ADDENDUM NUMBER TWO

RFQ # 7535371

TITLE: Construction of a New Fixed Pier and Dredging at Ft. Adams

NOTICE OF ADDENDUM NUMBER ONE (1)

SITE INFRASTRUCTURE IMPROVEMENTS
**PROPOSED NEW PIER
WAVE FENCE ARRANGEMENT SHEET 2 OF 2**
FORT ADAMS STATE PARK, NEWPORT, RHODE ISLAND

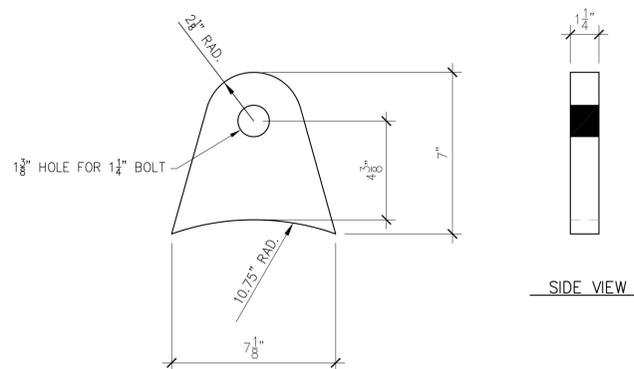
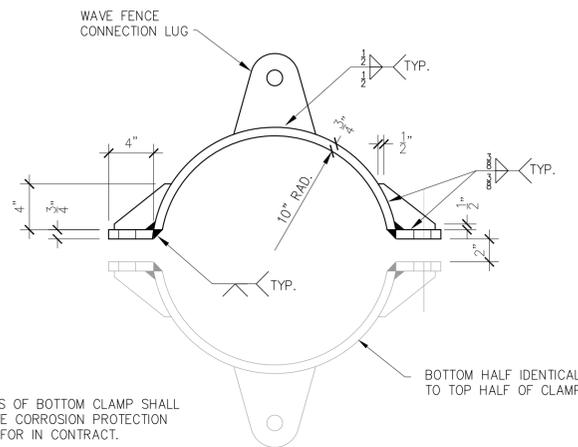
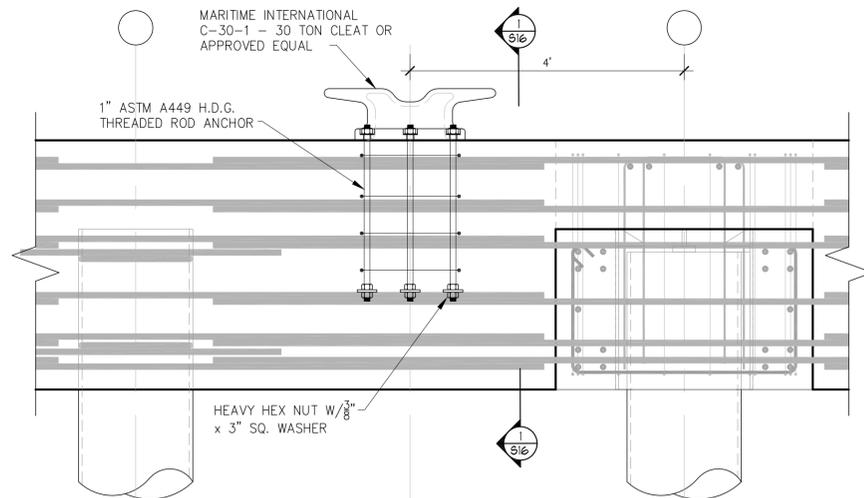
24. Horizontal limit for Wave Fence is shown from Line "O" to Line "15," and extending east of Line "15" (Sheet S3). Attachment details (Sheet S14) will only accommodate Wave Fence between Pipe Piles. Please provide attachment details for Wave Fence from Line "O" to Line "0.1," and east of Line "15."

The wave fence shall be terminated at the west face of pile line 15. A detail has been provided on Sheet S15 for the connection of the bottom of the wave fence west of pile line "0". This detail will be reviewed at the time of construction. Please see Addendum No. 1, Item 21.

CORNER ARCH FENDER SYSTEM
SCALE: 1" = 1'-0"

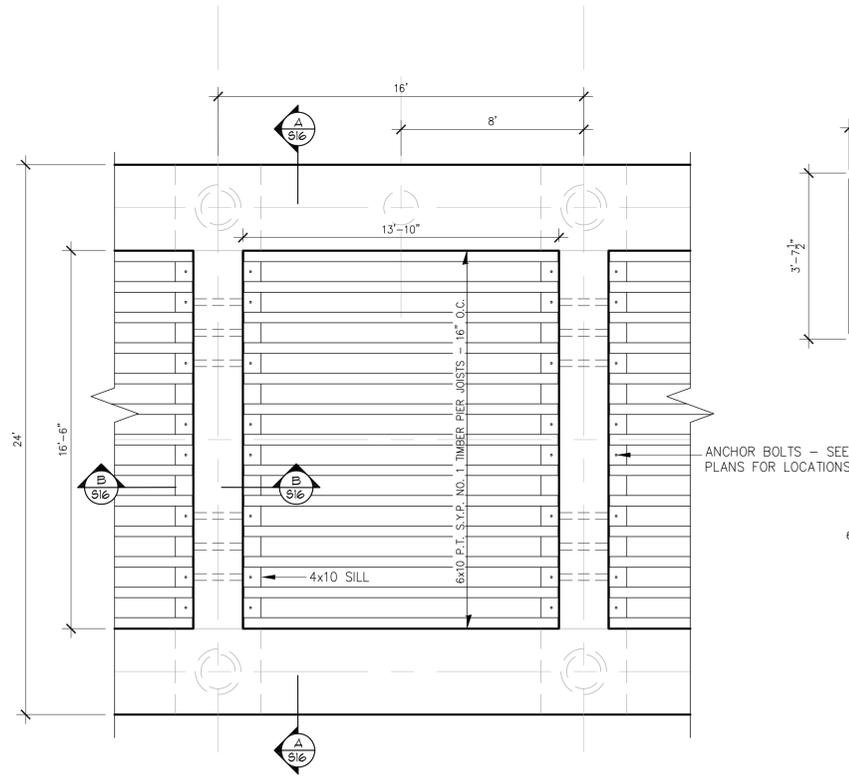
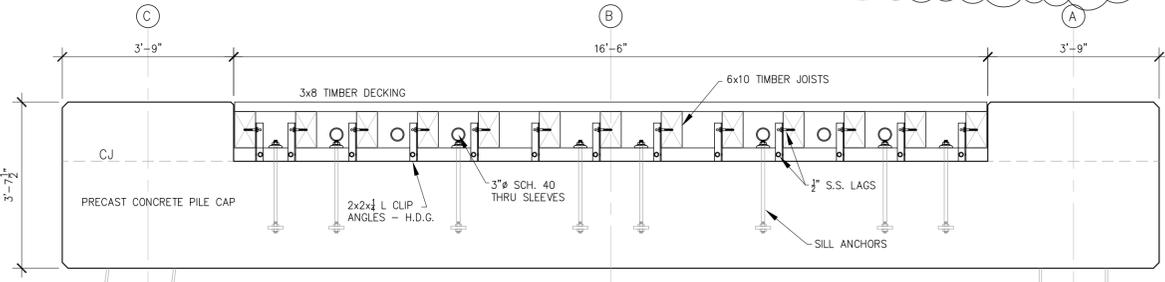
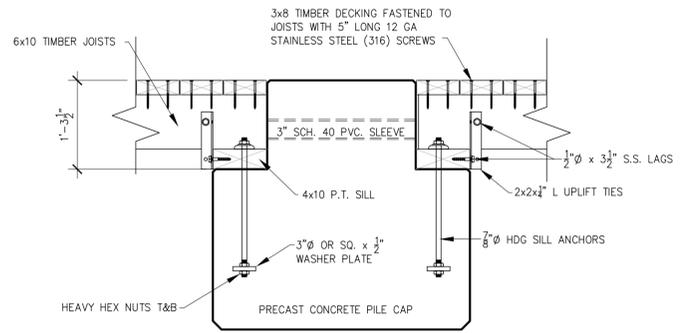
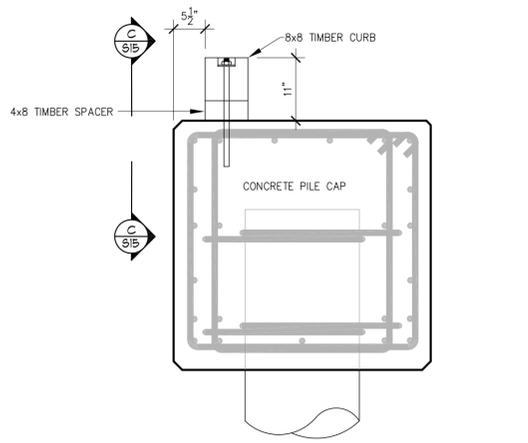
20. Please provide details of your requirements for the Arch Corner Fender.

Sheet S16 has been revised to show the details for the Arch Corner Fenders. Please see Addendum No. 1, Item 22.

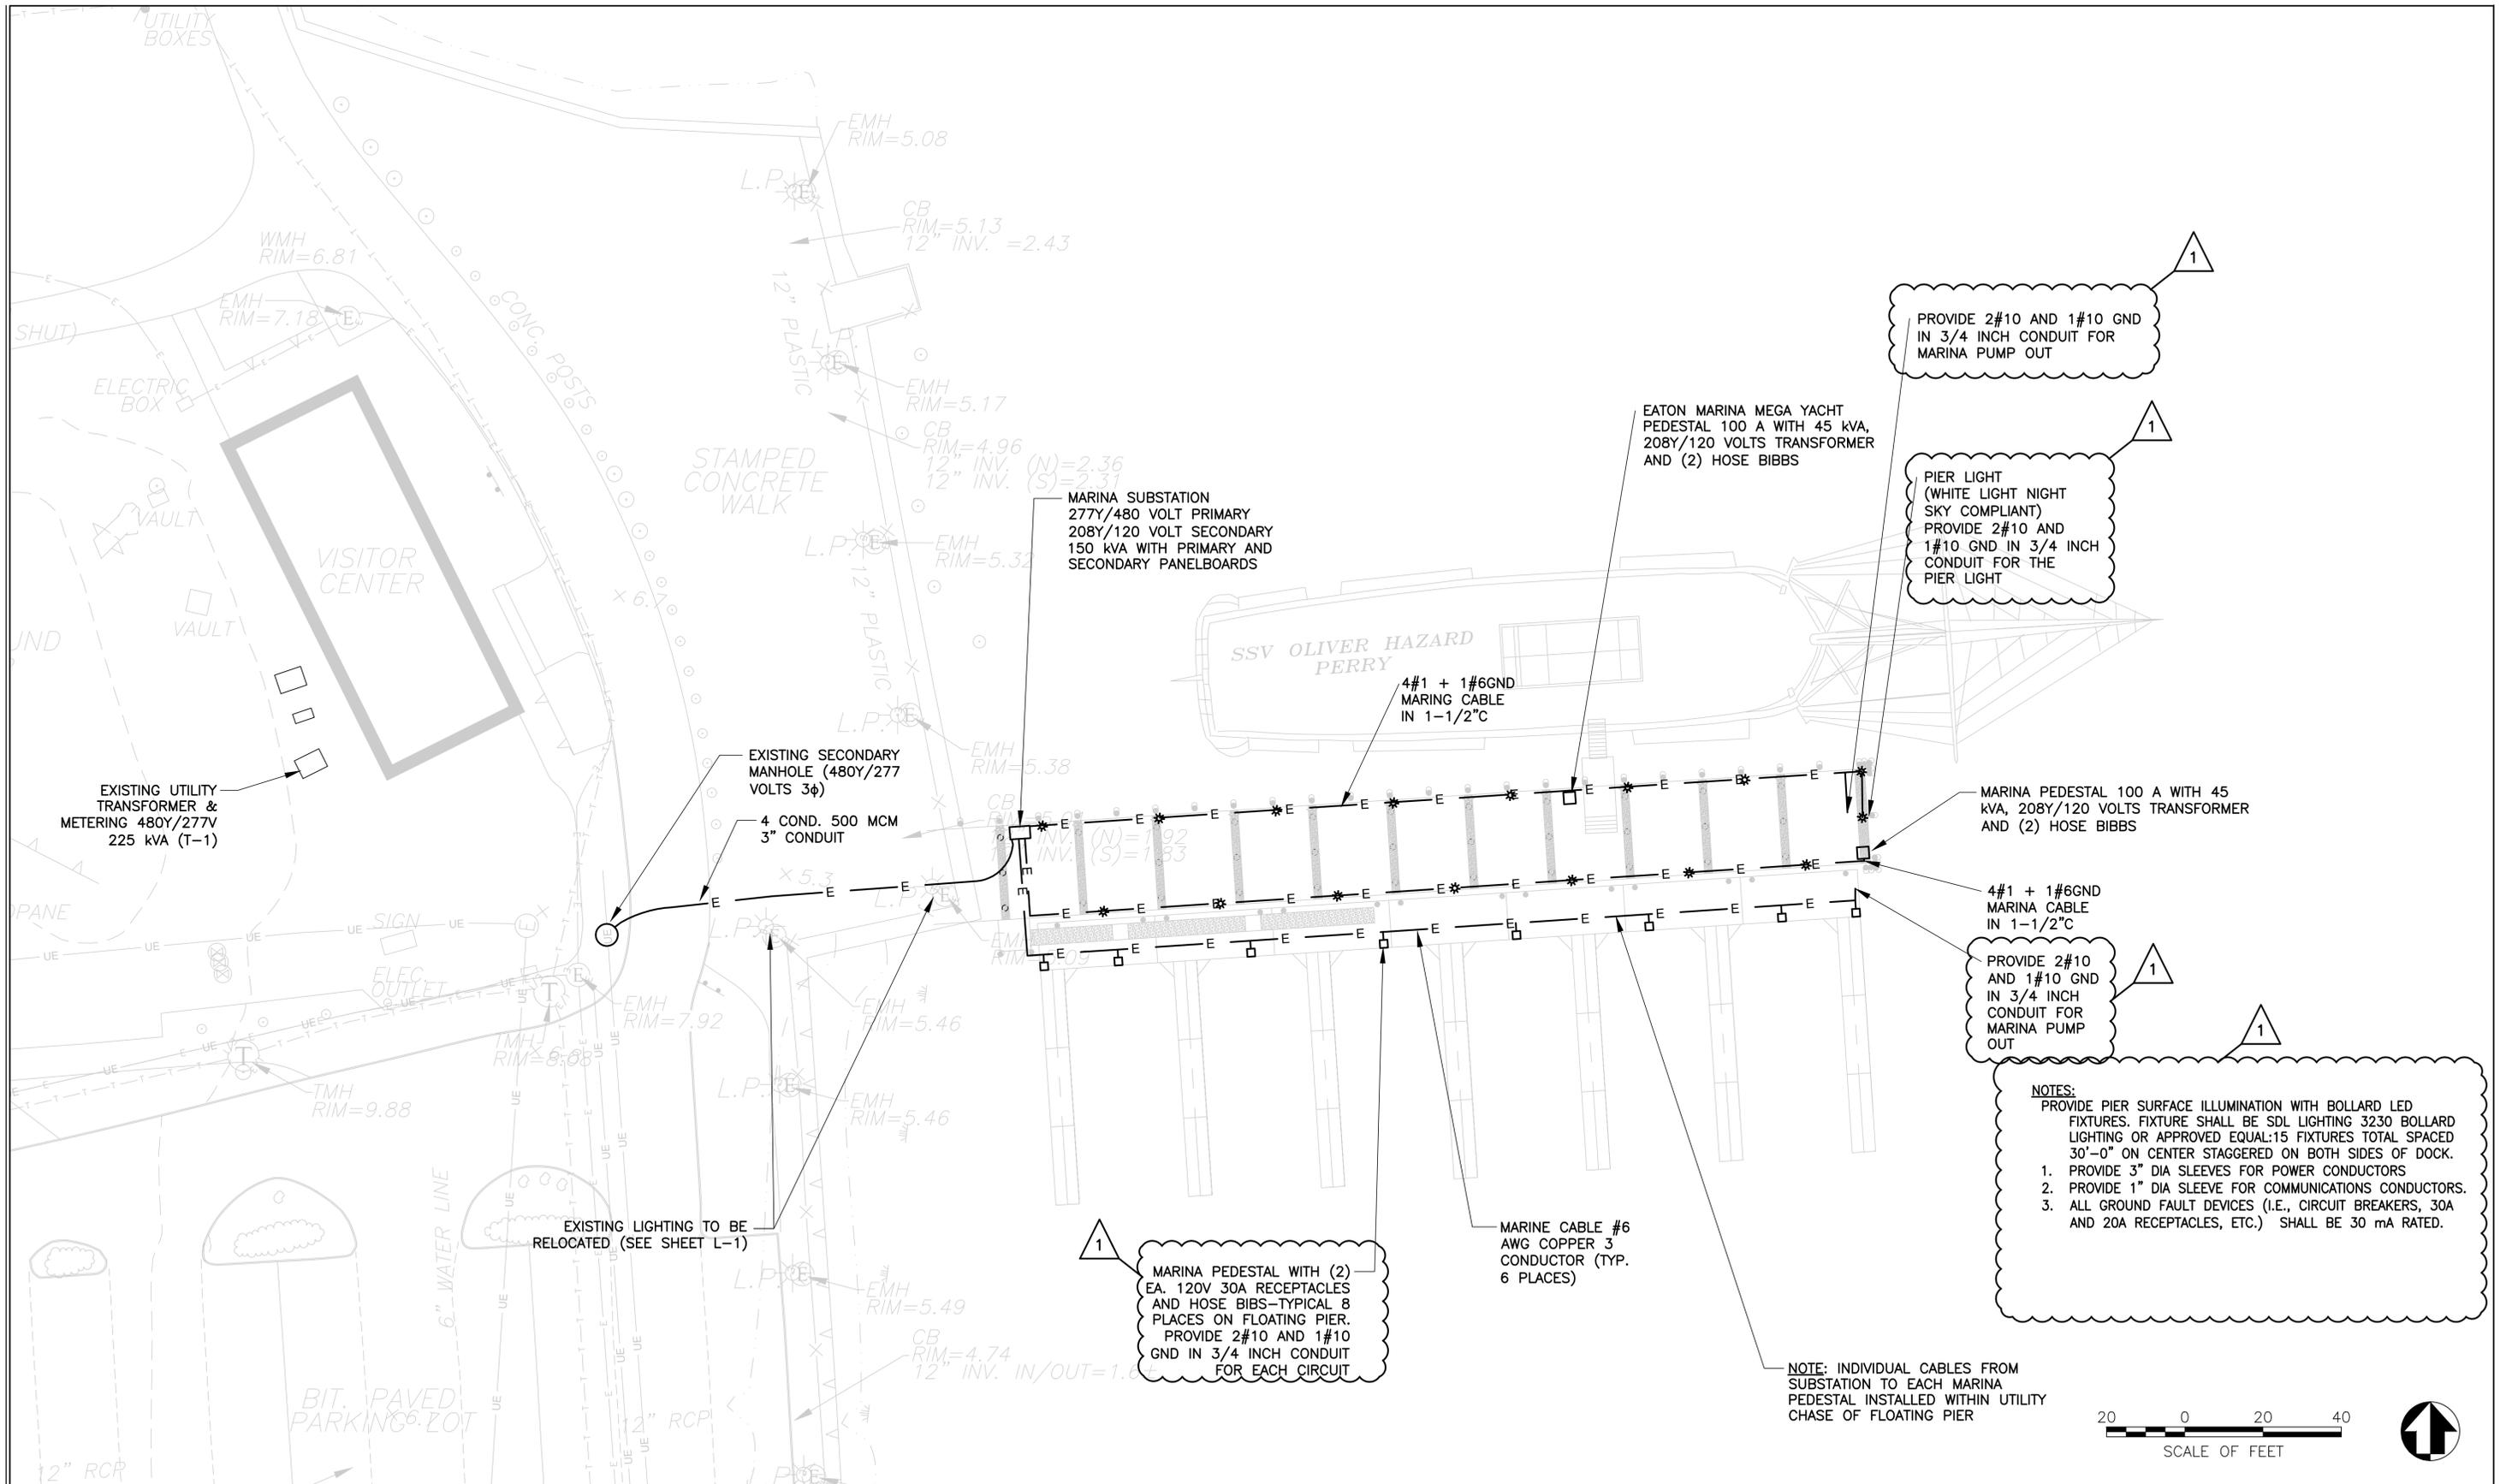
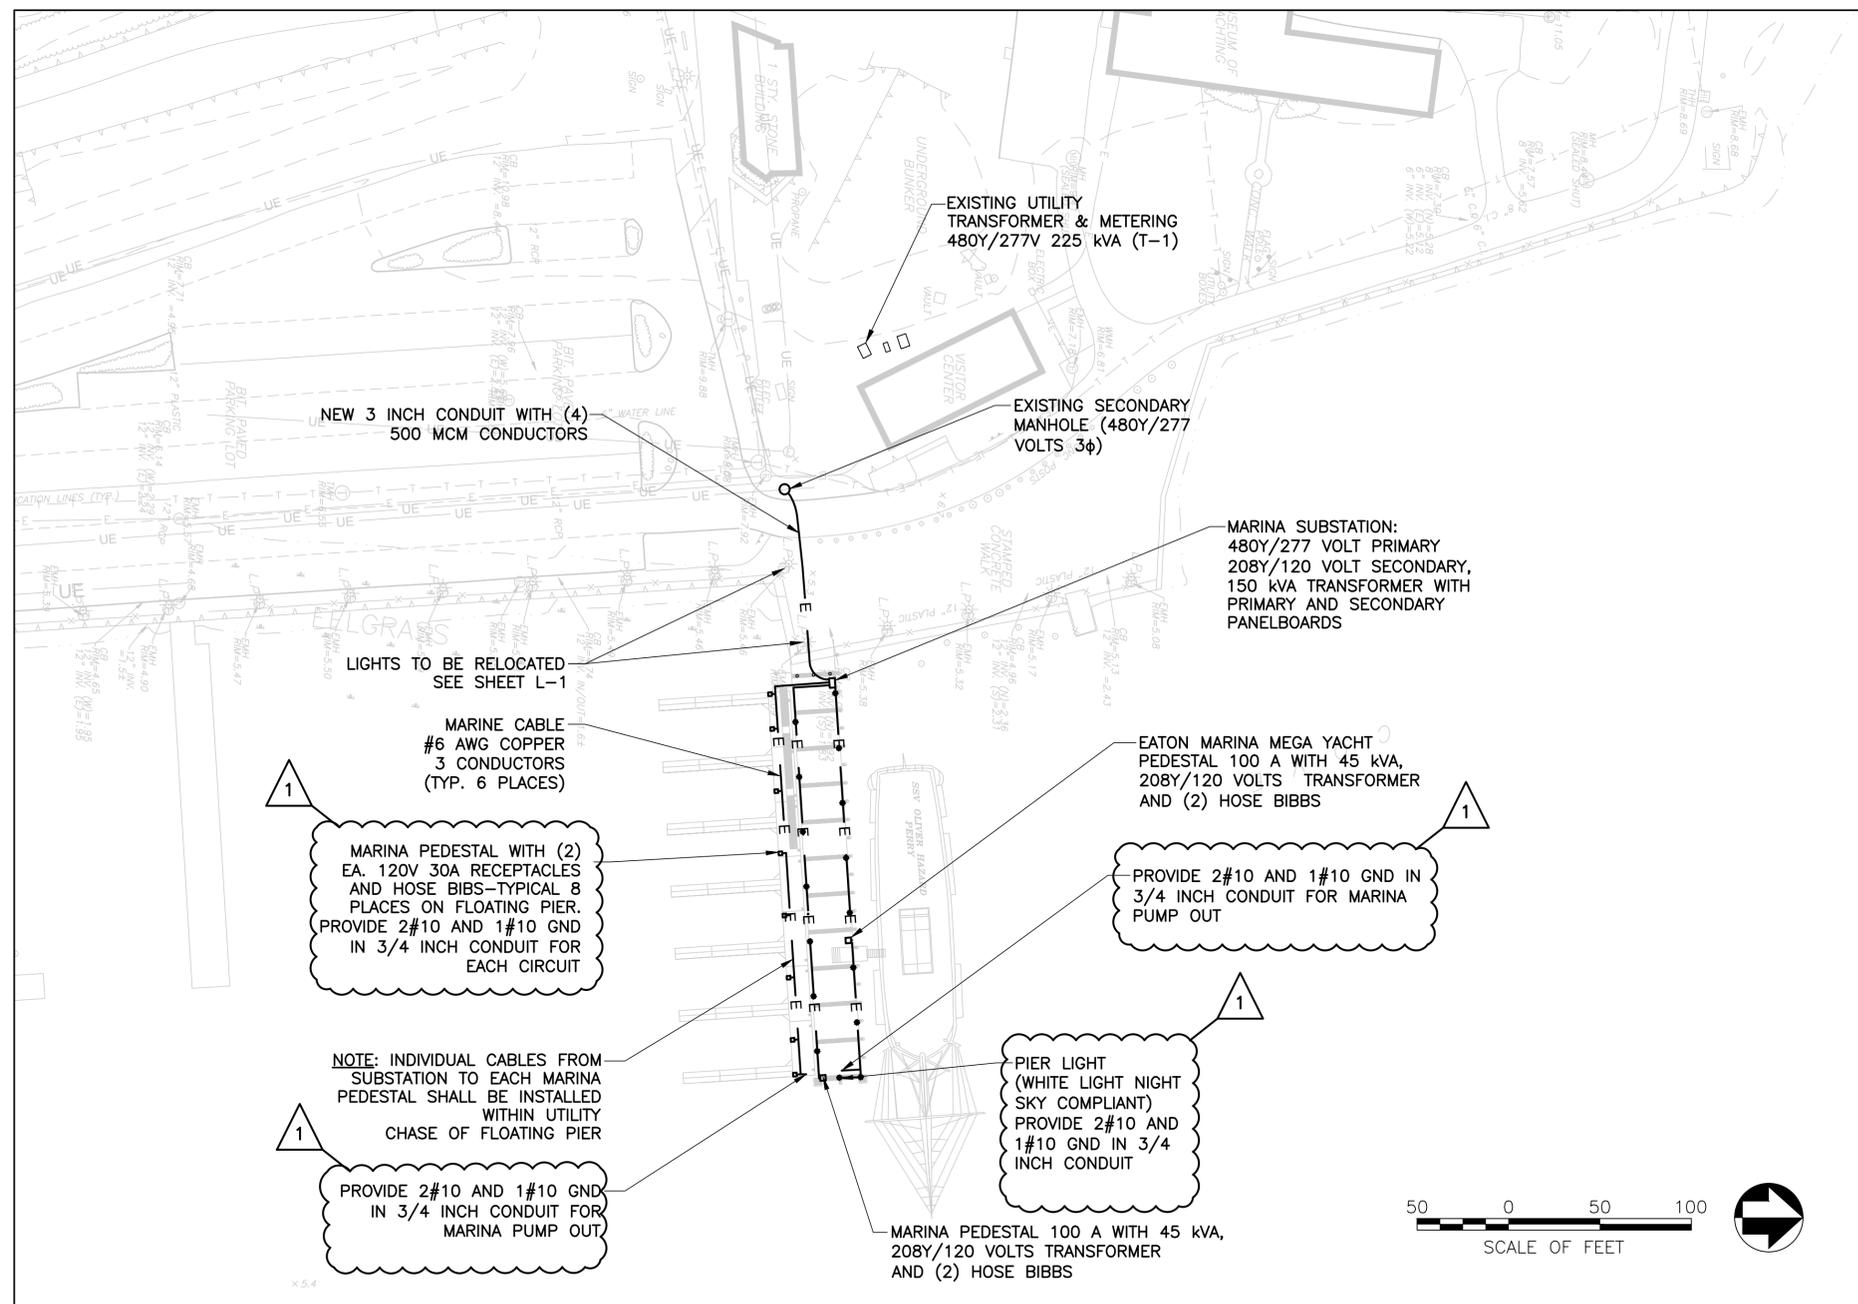
38. Sheet E-2 calls out six marina pedestals but shows eight pedestals. Please clarify.

Please see Addendum No. 1, Items 8, 24 and 25. The schematic layouts shown on C-3, E-1, and E-2 are correct. There are a total of eight pedestals proposed. The note has been revised accordingly.
